Washington Metropolitan Area Transit Authority
ANNUAL INTERNAL REVIEW 2017

Metrorail Major Repair & Overhaul (MRO) Processes

QICO Internal Review

July 19, 2017

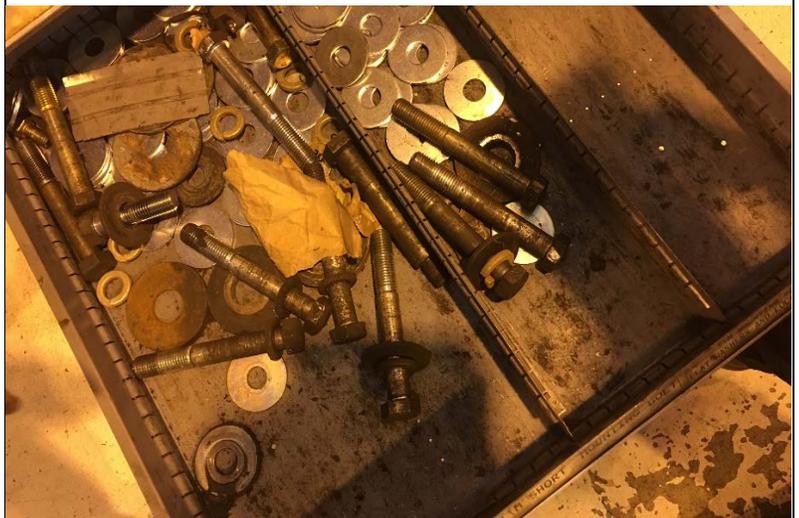
Used brake pads, brackets, bolts, and air hoses unorganized on storage shelves.

Photograph #12

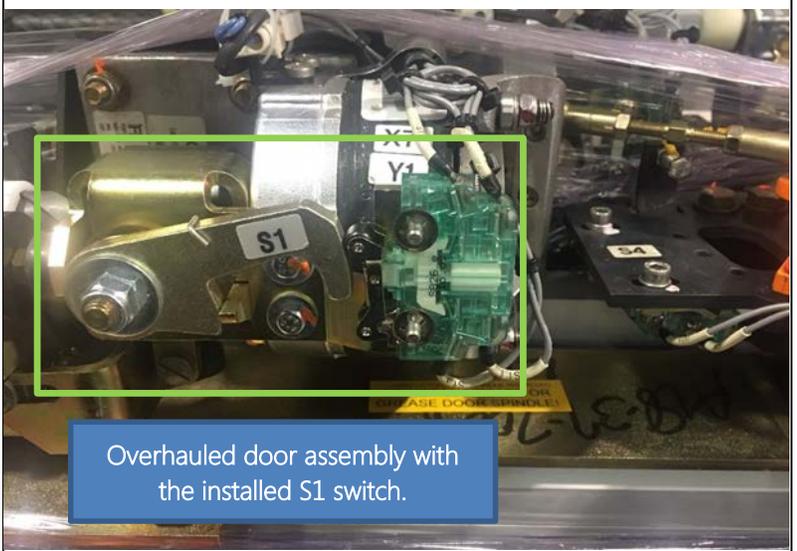
At Greenbelt Annex MRO, an inspected electrical component was left without any electrostatic discharge (ESD) protection.

- Finding 1.7

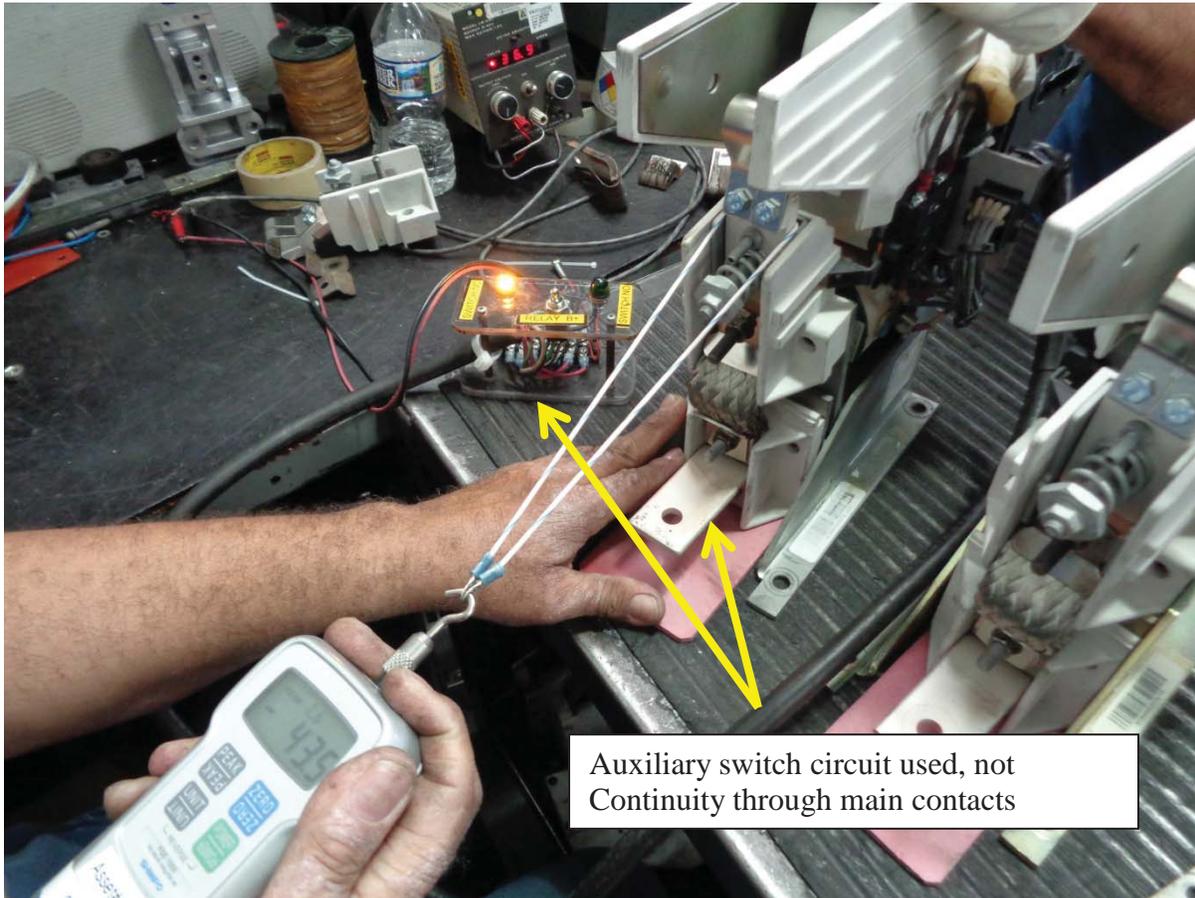
1. The Technicians are not following HRMM Section 3-5-18; Page 3-5-157 and 3-5-158 when "Setting Main Pole Pressure". They are using the Auxiliary switch circuit to note the spring pressure on the contact tips. When the main contacts open, they are looking for a value above 44lbs (pulling the armature away from the energized coil). Per Section 3-5-18, 44lbs is the recommended range of the pressure gauge to be used. The actual spring setting value should be 22lbs +/- 2.2lbs, and continuity through the main contacts should be used to note the spring pressure on the main contact tips, when the spring starts to compress and the contact tips open.
2. This procedure is also called out in the Microeletica Scientifica Document, and is the same as HRMM Section 3-5-18.
